JAPAN's Comments

Informal document GRSG-102-34
(102nd GRSG, 16-20 April 2012
agenda item 6)

On OICA document Submitted by the expert from OICA

On Informal document No. GRSG-102-xx Submitted by the expert from Germany

Cases where the change in the RUPD height from 100 mm to 150 mm will be difficult (Vehicles with retractable tailgate lift)

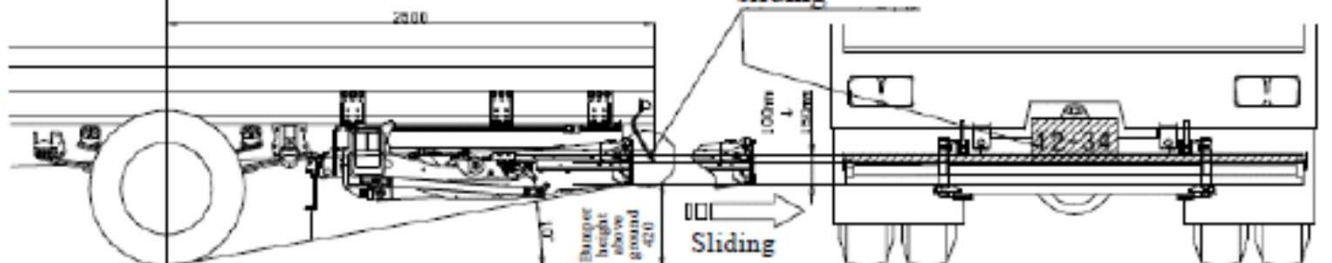
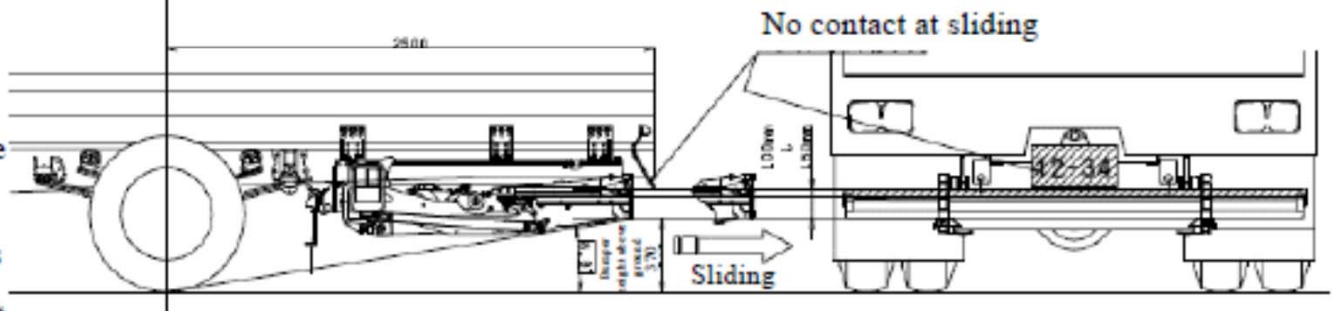
- * If the bumper is extended upwards to keep the departure angle, the tailgate will come in contact with the registration plate when it slides backwards.

- * If the tailgate installation position is lowered by 50 mm in order to avoid contact with the registration plate, the departure angle will be below 10°, making some vehicles unable to run.

- * If the bumper is extended downwards without lowering the tailgate installation position, it will still result in the situation depicted at right.

Diagram [2] Vehicles with movable RUPD for dumping ;N3

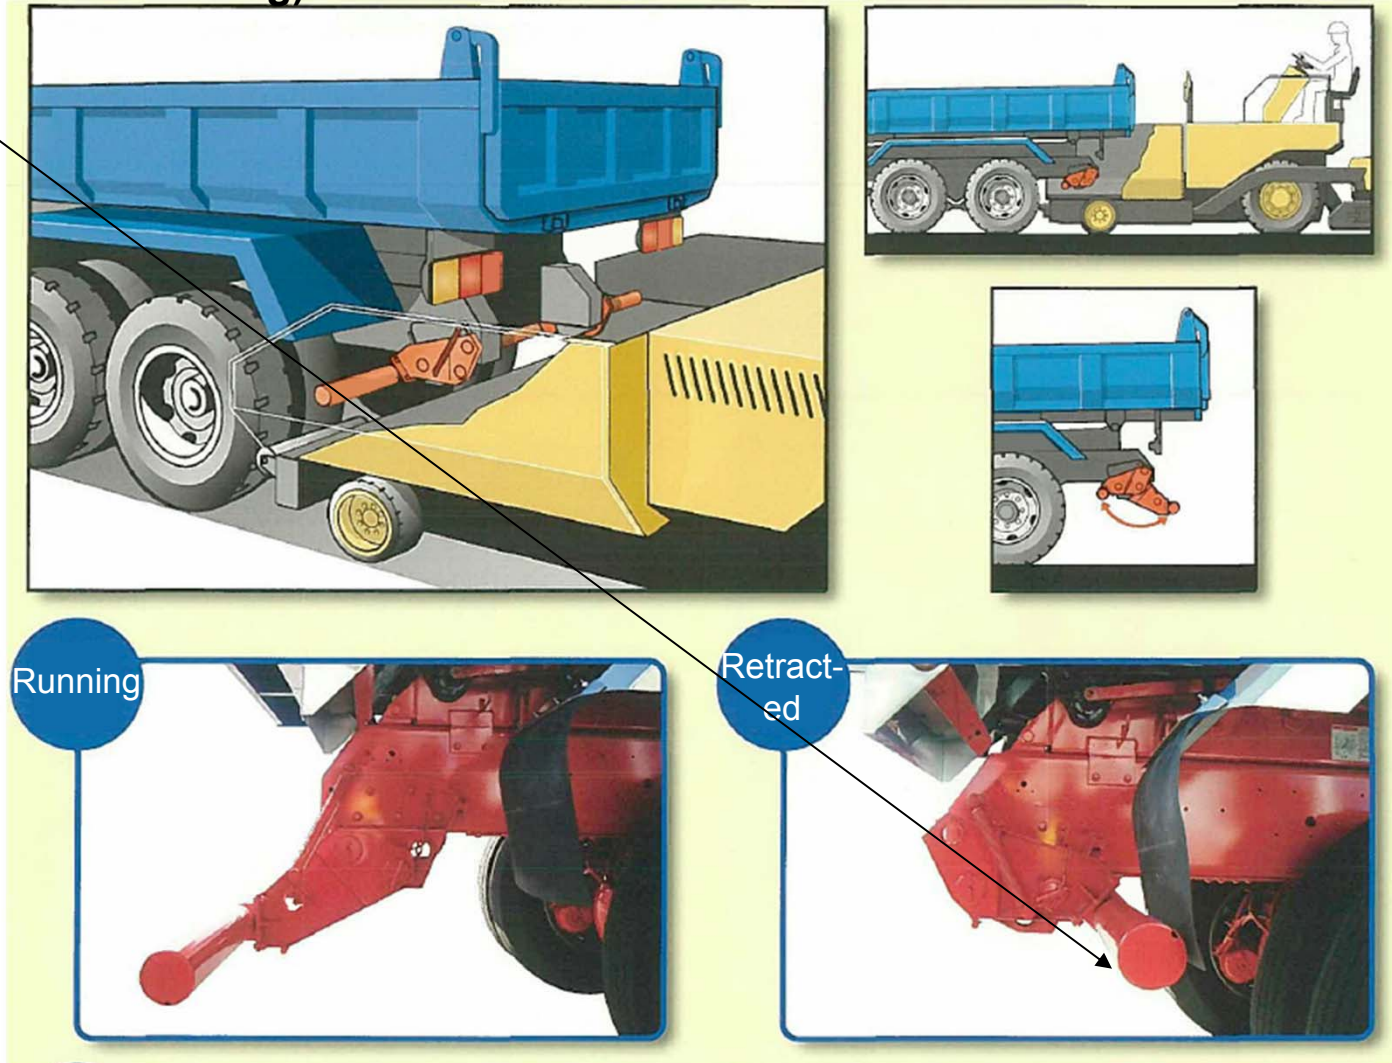
Cases where the change in the RUPD height from 100 mm to 150 mm will be difficult

Vehicles with movable RUPD for dumping (vehicles with retractable bumpers for asphalt finisher docking)

Diagram [3] N2 vehicles with GVW 7 t or less ; N2

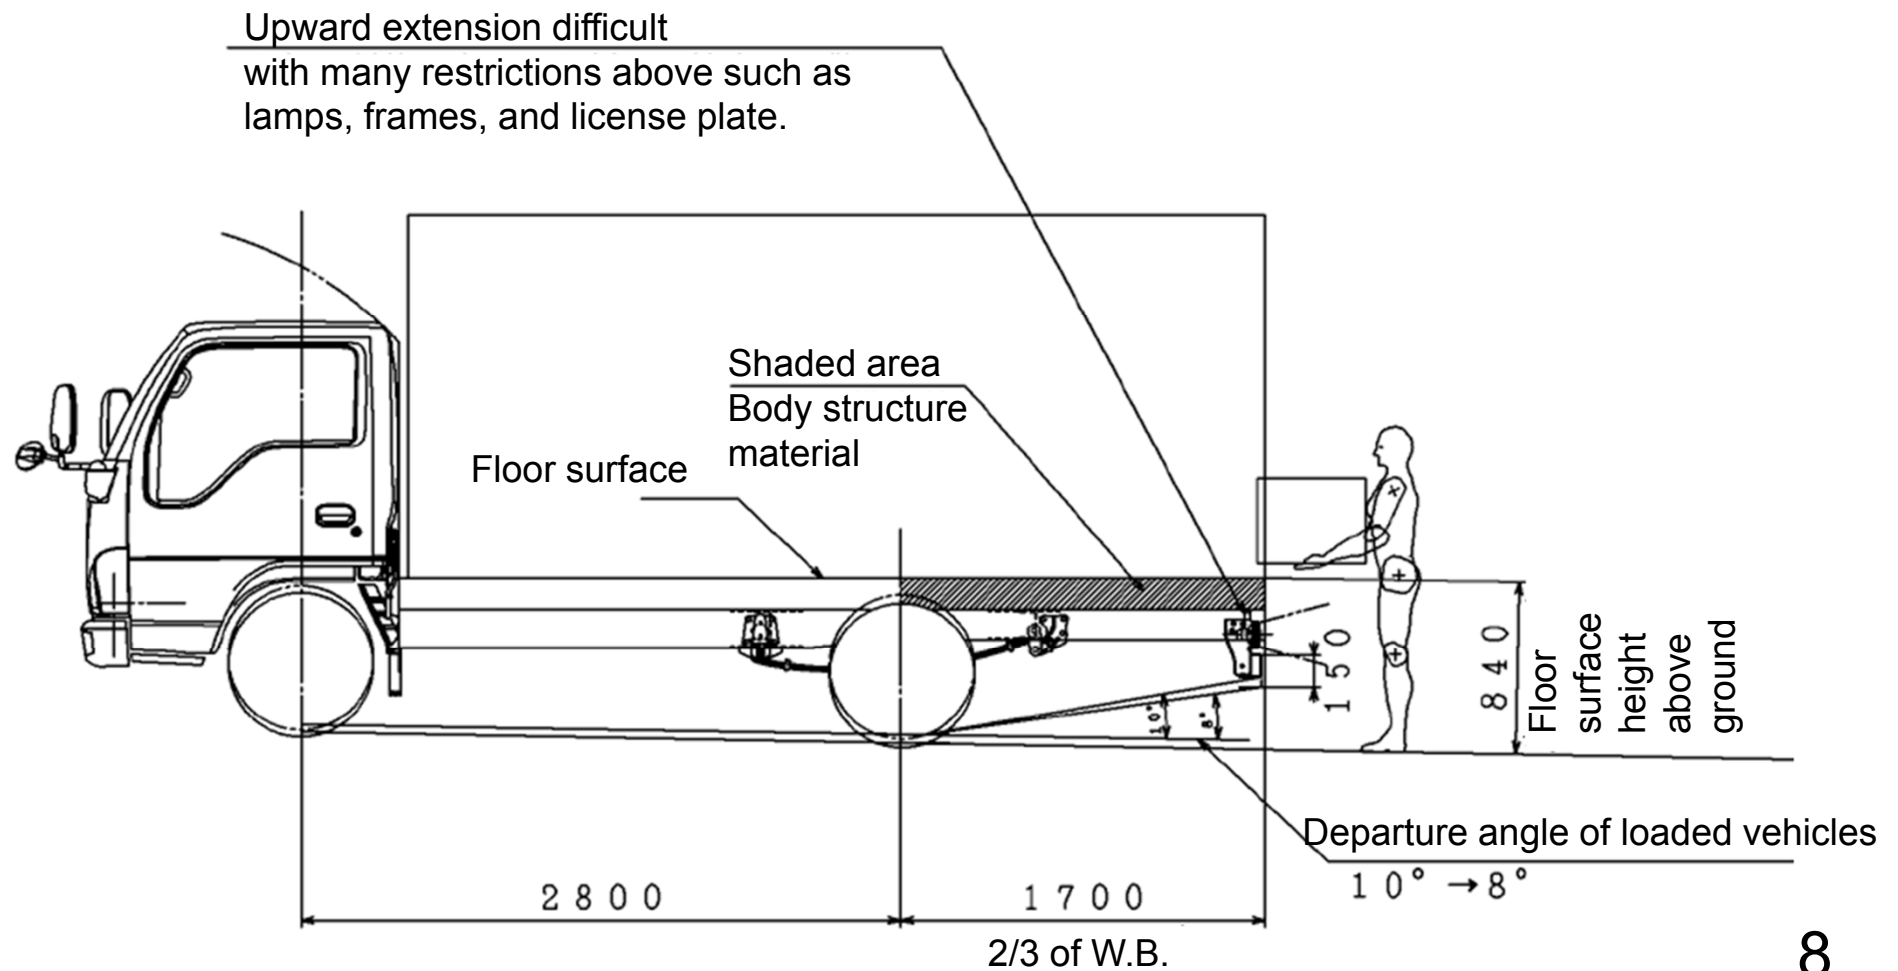
Cases where the change in the RUPD height from 100 mm to 150 mm will be difficult

Diagram [4] refer;GRSG-101-27 P5 – 8

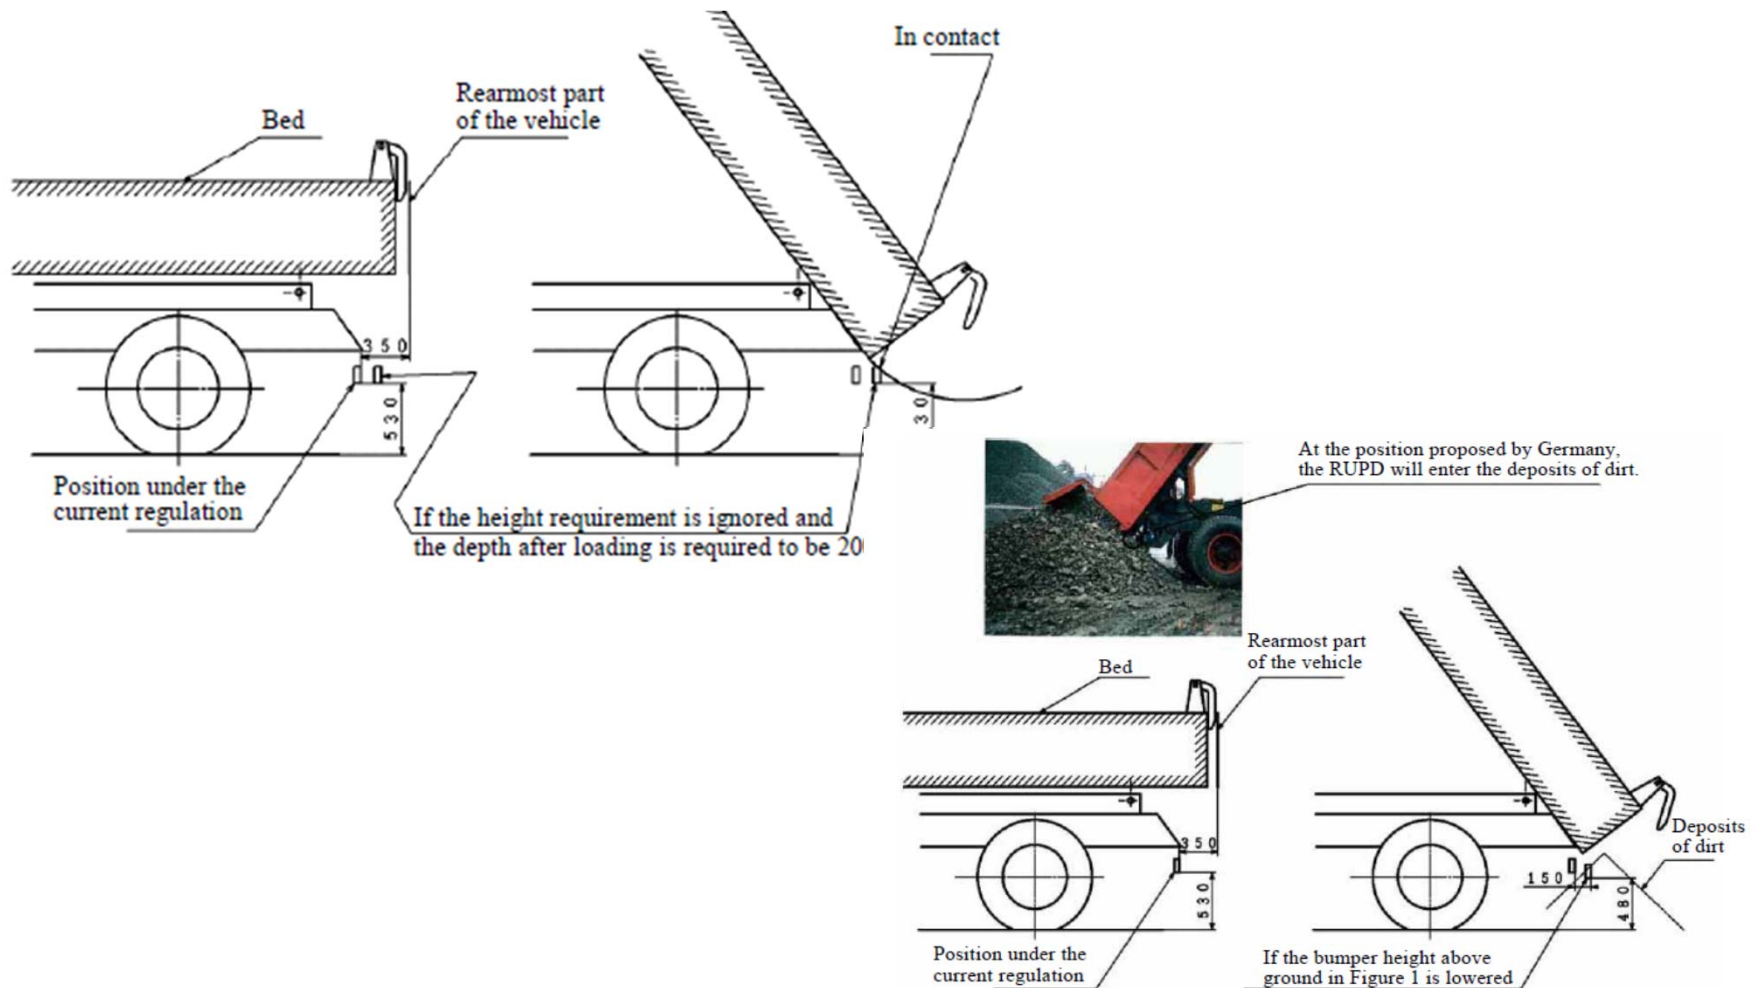
Cases where the ground clearance with respect to the underside of the protective device of 550mm is necessary

Cases where the RUPD installation position of 200 mm will cause technical problems in constructing the vehicle structure .

The distance of 350 mm is necessary for vehicles with Dump trucks.

Diagram [6] refer;GRSG-101-27 P10 ;N3

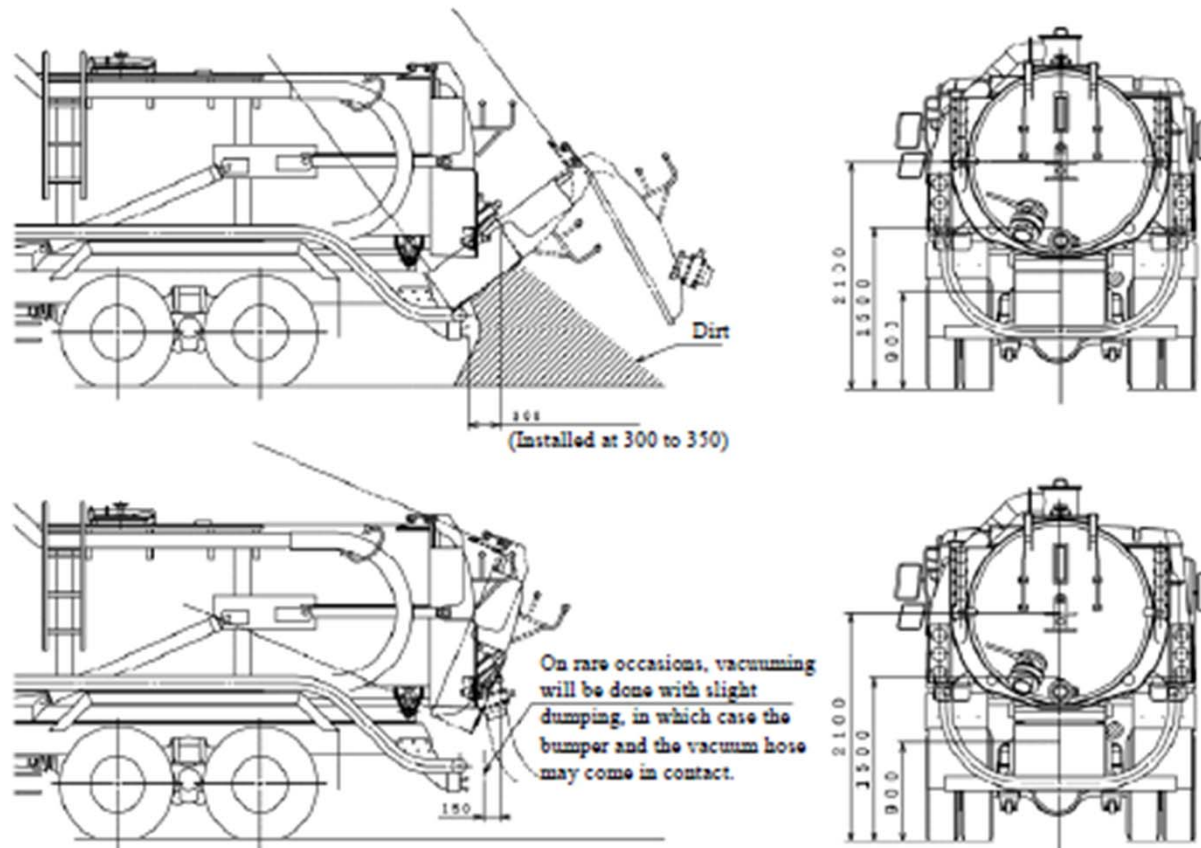
Cases where the RUPD installation position of 200 mm (from the rearmost part of the vehicle) will cause difficulties in usage

Vacuum Trucks: When the truck dumps the load, it will come in contact with the RUPD, making the dumping work difficult. With the RUPD being located too close to the vacuum hose, handling of the hose will be difficult when the truck vacuums the load.

Concrete mixers: When the concrete is discharged, the RUPD location will be farther away than the current position, which will cause danger in the discharge work.

**Diagram [7] Construction equipment carriers - Tilt type vehicles with front jacks
;N2**

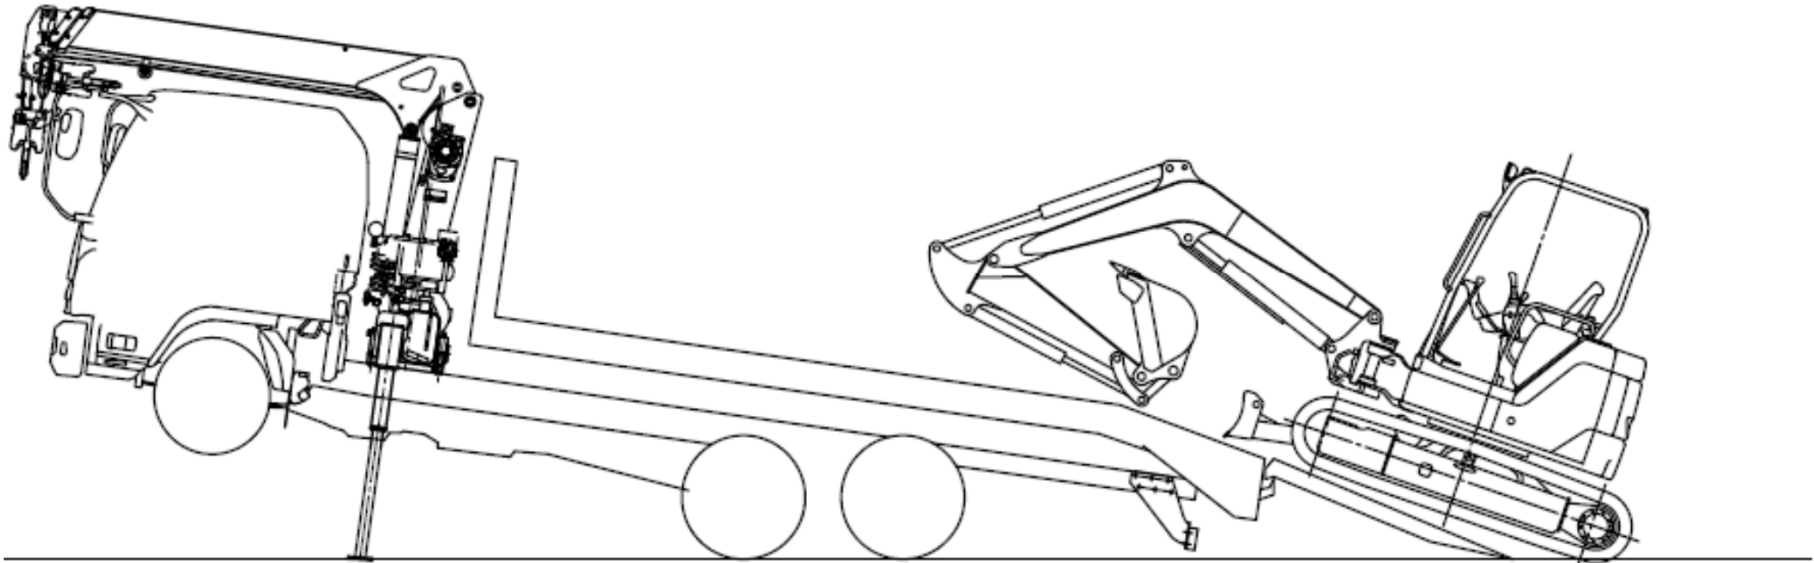
Cases where the ground clearance with respect to the underside of the protective device of 550mm is necessary

Cases where the RUPD installation position of 200 mm will cause technical problems in constructing the vehicle structure .

The distance of 350 mm is necessary for vehicles with Dump trucks.

Diagram [10] refer;GRSG-101-27 P4 ;N2

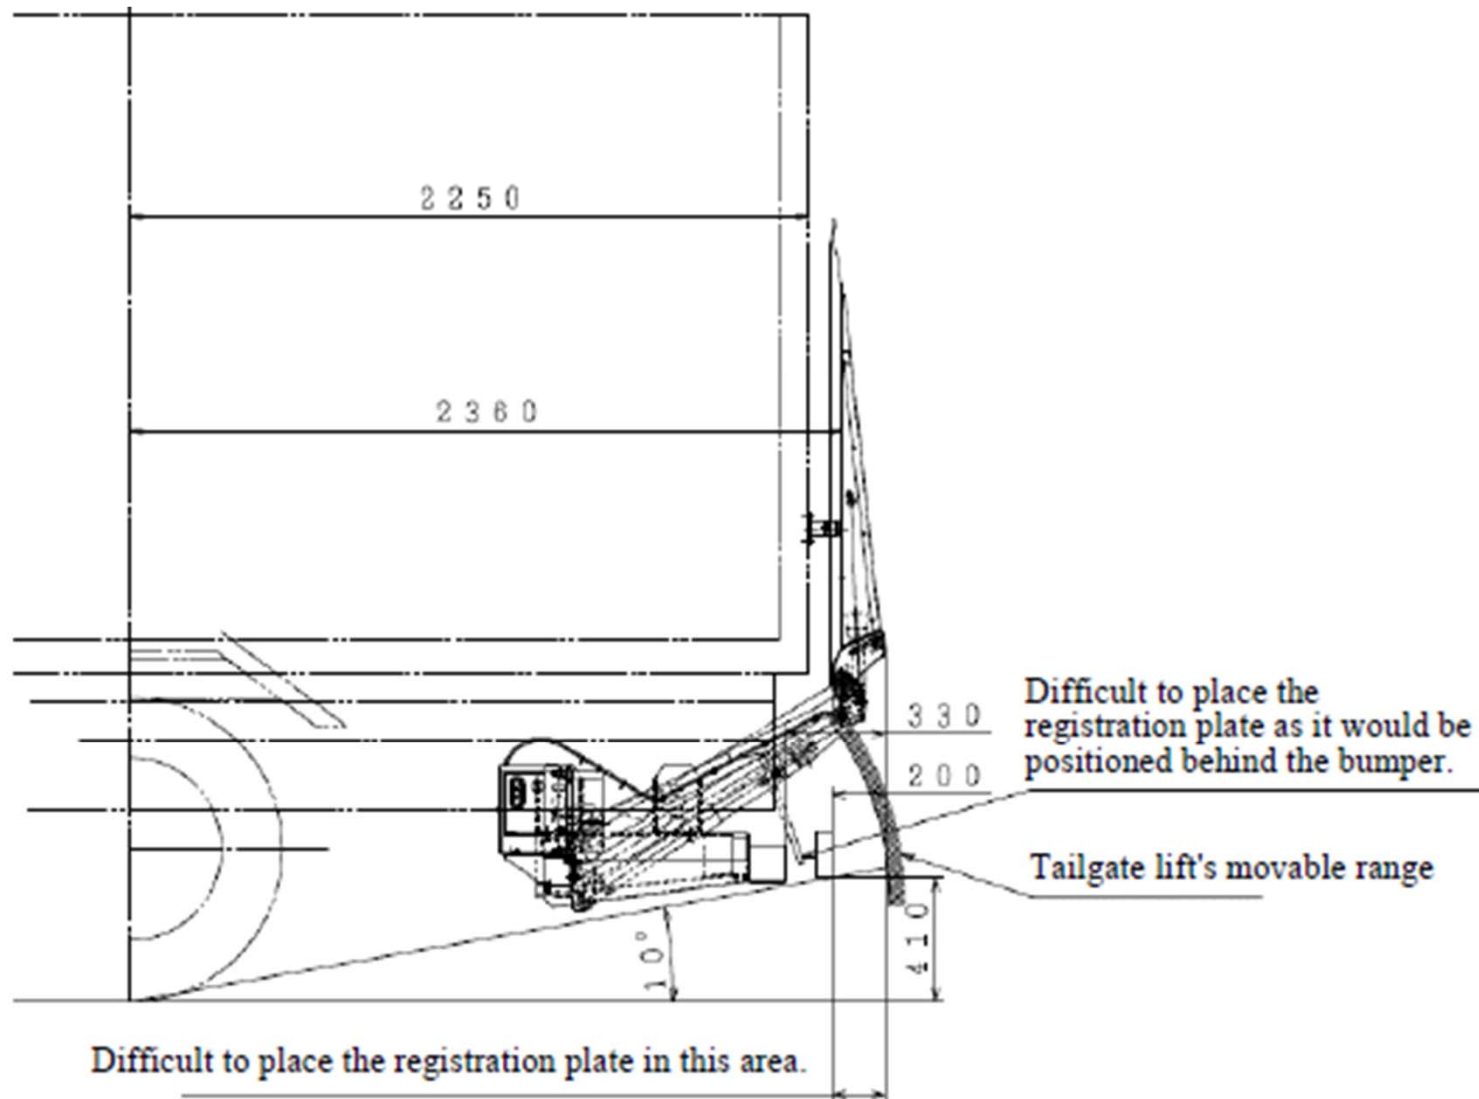
Cases where the RUPD installation position of 200 mm will cause technical problems in constructing the vehicle structure (Vehicles with platform tailgate lift)

Diagram [12] refer;GRSG-101-27 P11 ; N2

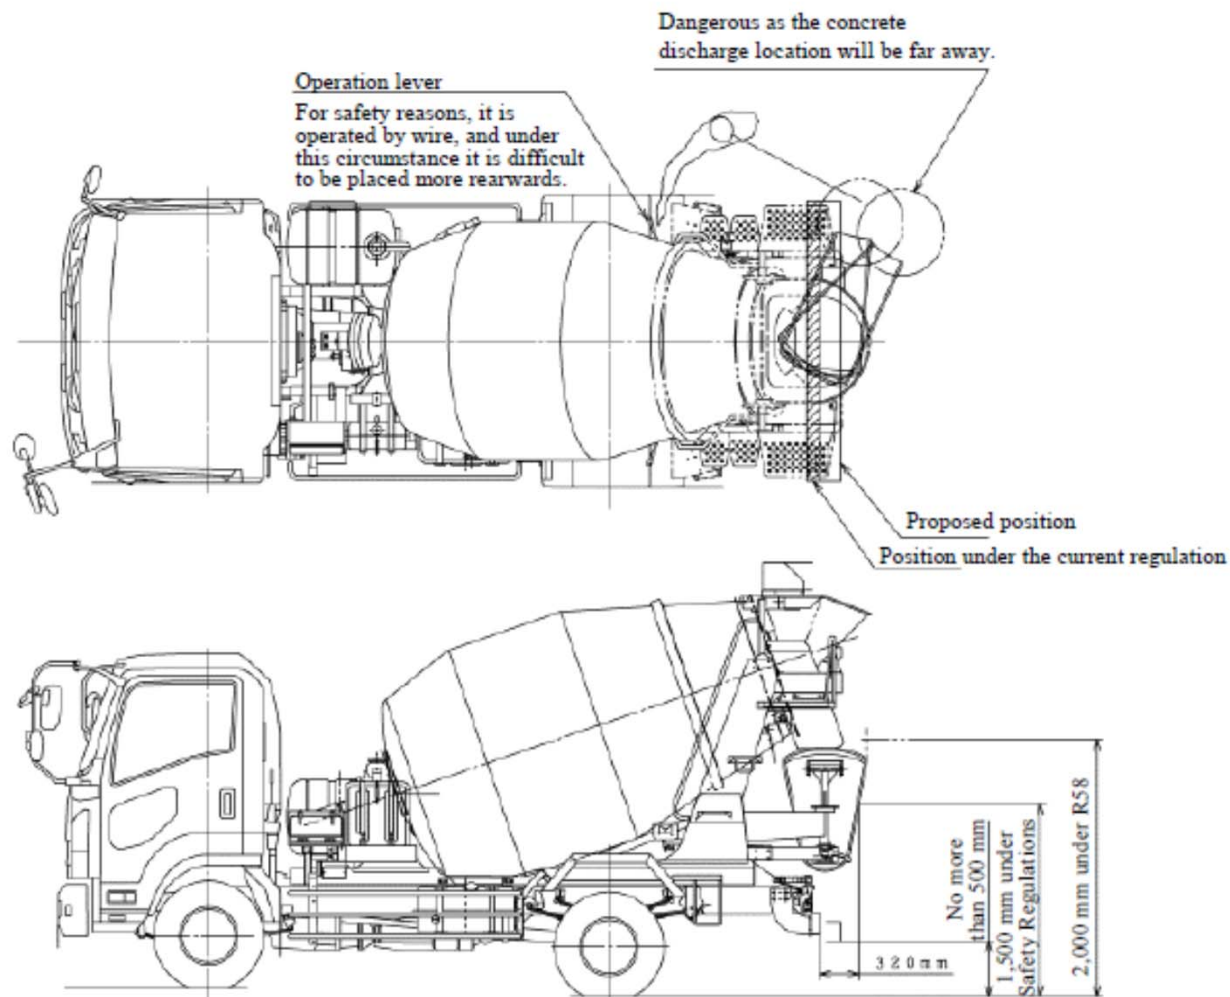
Cases where the RUPD installation position of 200 mm (from the rearmost part of the vehicle) will cause difficulties in usage

Concrete mixers: When the concrete is discharged, the RUPD location will be farther away than the current position, which will cause danger in the discharge work.
